## **QUESTIONS AND ANSWERS**

## IFB 090324DW FOX MEADOWS ES AND SHEFFIELD HS ROOF REPLACEMENT

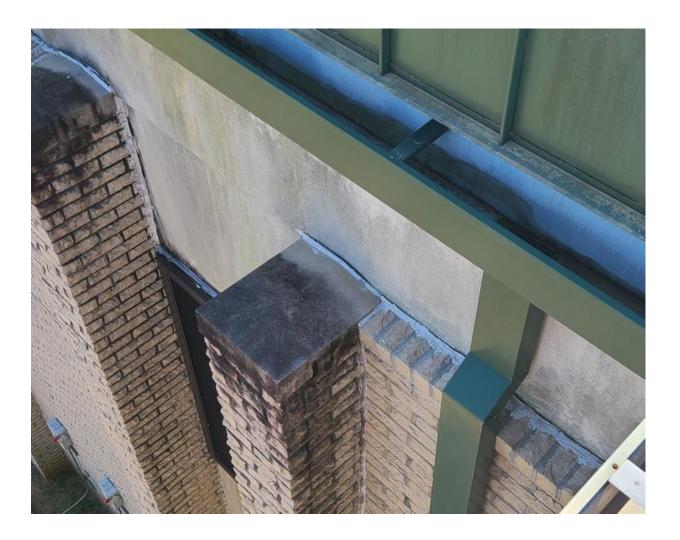
22.) Some buildings seem to have original limestone copings. Please identify the scope of work at these parapets.

This will vary depending on any through the wall flashing, Edge metals may be required.
